**BEFORE HEARING COMMISSIONERS  
FOR THE PALMERSTON NORTH CITY COUNCIL**

**IN THE MATTER** of proposed Plan Change I: Increasing Housing Supply and Choice to the Palmerston North District Plan

**SECTION 42A TECHNICAL REPORT OF MARY WOOD  
ON BEHALF OF PALMERSTON NORTH CITY COUNCIL**

**STORMWATER**

Figure 1 Annotated 100-year model output (copied from Stormwater Servicing Assessment) showing location of submissions relating to overlay extents

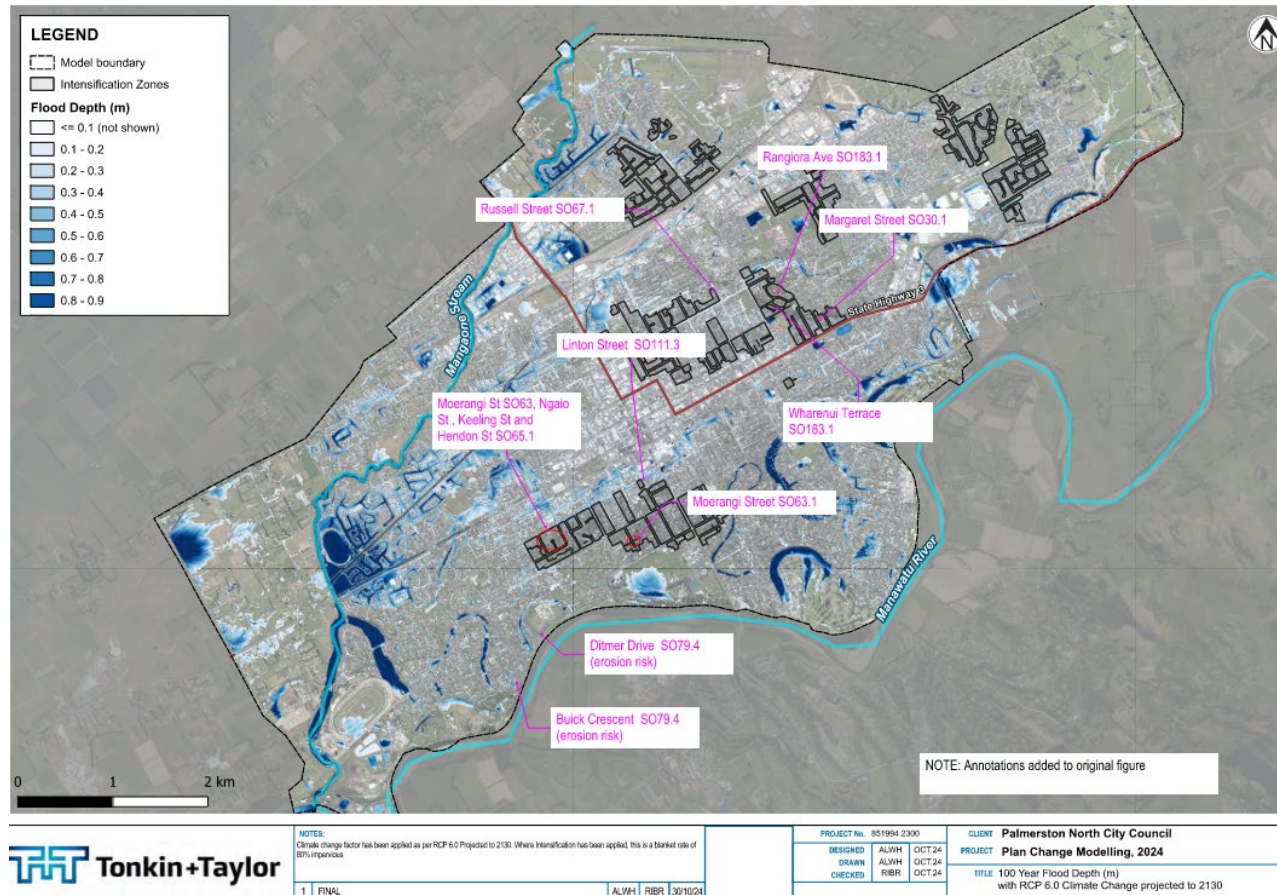
32. I have annotated a figure from the SSA and provided this as **Figure 1** in the Appendix to my evidence – this shows where flooding issues have been indicated in submissions, overlain on modelled flood depth in a 100-year event.

36. While some of the submissions in my opinion reflect comparatively shallow flooding of the roads, there is reference to more significant flood depths.

37. Flooding noted on Linton Street between Ferguson St to College St made reference to depths reaching inside vehicle doors. I have reviewed the contour data for this section of road. This section of the road drains to the north, is flat and may have some smaller localised depressions within the road reserve that may result in localised deeper flood depths without necessarily being

representative of a wider flood risk with redevelopment. No flooding is predicted in this area in the T&T modelling report.

38. Similarly, the southern end of Margaret Street is flat and contours indicate some localised depression areas that could be challenging to drain. These depressions do not appear to be deep. There is a flat gradient to Main Street for the southern end of Margaret Street that may impact how quickly water will drain during and after a rainfall event but there is no flooding predicted in this area in the T&T modelling report.

40. Based on review of the maps provided in the SSA and the areas noted in the submissions, I do not believe there is sufficient information to indicate that the Stormwater Overlay should be altered to include the areas referenced in submissions listed in paragraph 31. I note that the Council review their District Plan every 10 years – at this time the overlay should be reviewed to allow for ongoing model update and network improvements that may have been undertaken.
